**SUBJECT: DEMONSTRATION / DELIVERY HOLD - Safety Recall 15S17**  
Certain 2015 Model Year F-150 Vehicles  
Upper Intermediate Steering Shaft Rivet Inspection

## CERTAIN 2015 MODEL YEAR F-150 VEHICLES — UPPER INTERMEDIATE STEERING SHAFT RIVET INSPECTION

FIGURE 1

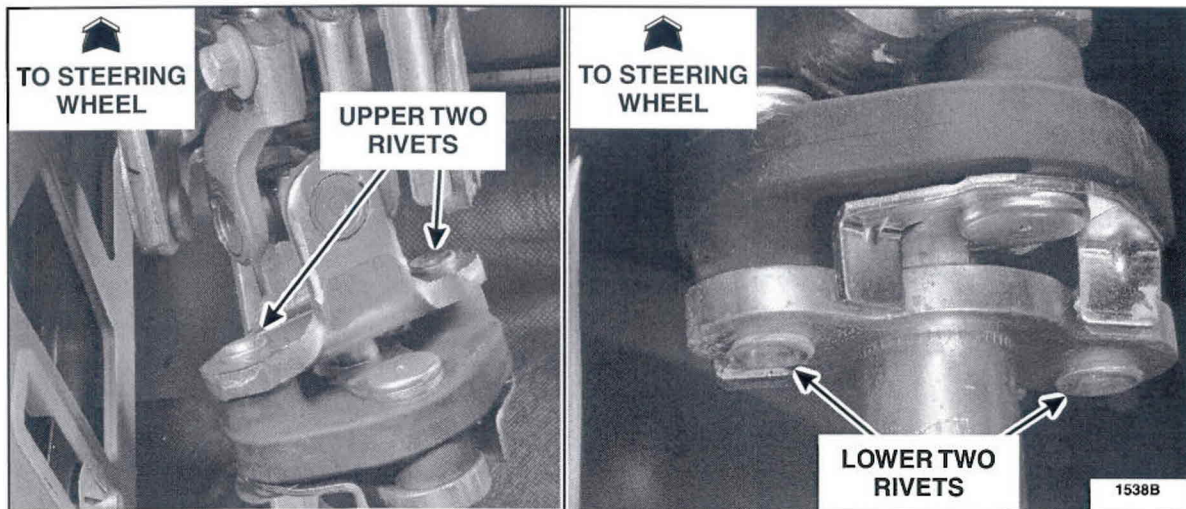
1. While looking upward from the driver's floorboard, locate the steering column upper intermediate shaft under the instrument panel (between the accelerator and brake pedals).
2. Locate the staked end of the two (2) upper and two (2) lower rivets in the upper intermediate steering shaft. See Figure 1.

FIGURE 2

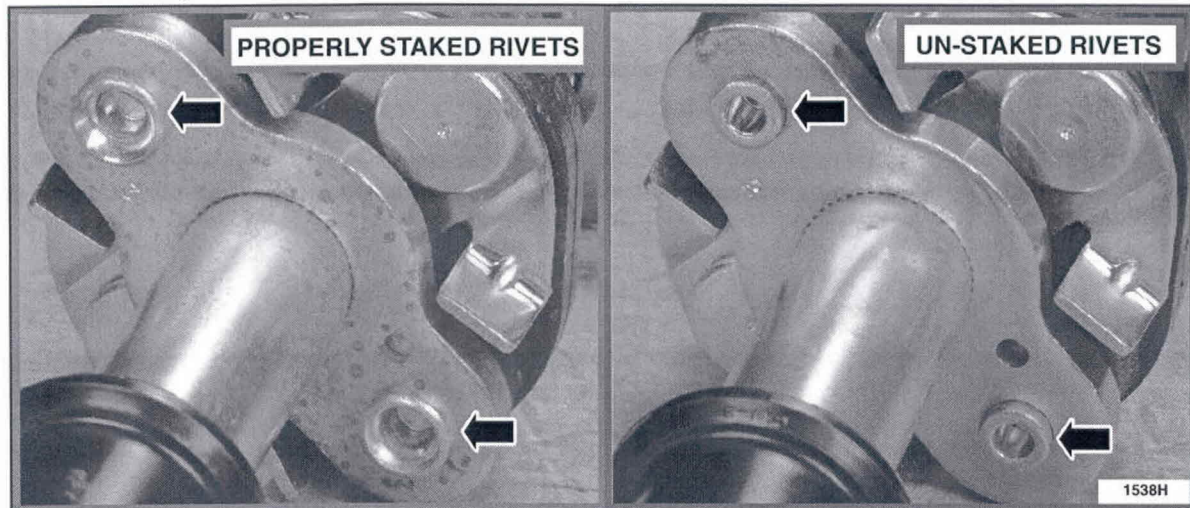
3. Inspect the four rivets both visually and using a 10 mm (3/8 in) wrench as a gauge to determine if they are staked:
- A rivet that is properly staked will have a pressed/convex shape at the tail end of the rivet and will not allow the 10 mm (3/8 in) open-end wrench to fit over the staked (tail) end. See Figures 2 and 3.
  - A rivet that is not staked will have a cylindrical or barrel shape at the tail end, may not be fully seated, and will allow the 10 mm (3/8 in) open-end wrench to fit over the (tail) end. See Figures 2 and 3.

FIGURE 3

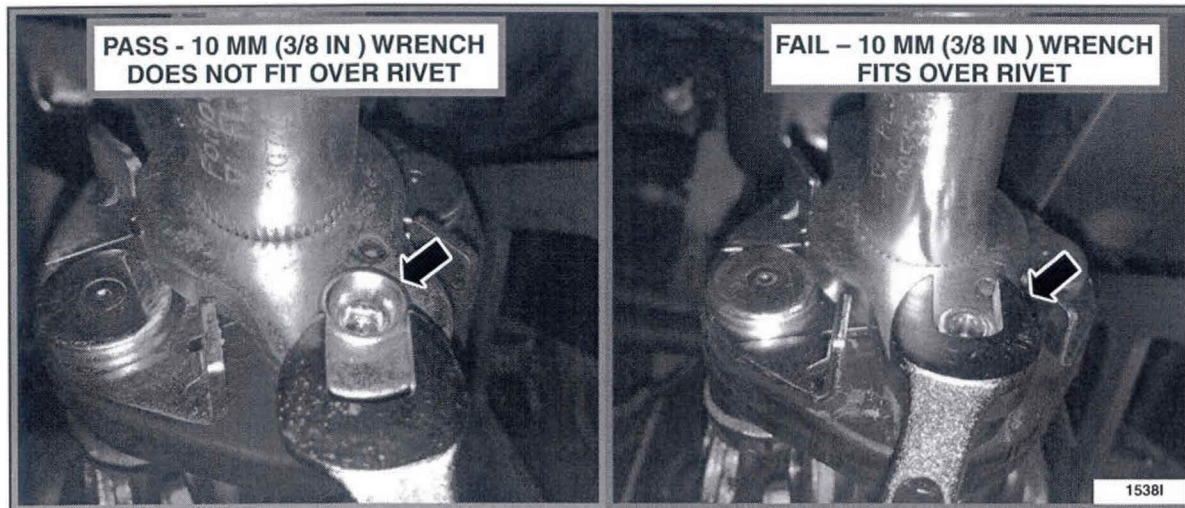
4. If any of the upper intermediate steering shaft rivets are not staked properly (inspection failed), replace the upper intermediate steering shaft. Please follow the Workshop Manual (WSM) procedures in Section 211-04.

**NOTE:** A photo showing details of the failed inspection part similar to Figure 3 above is required if a *new* upper intermediate steering shaft is needed. See dealer bulletin "Attachment II" for further information.
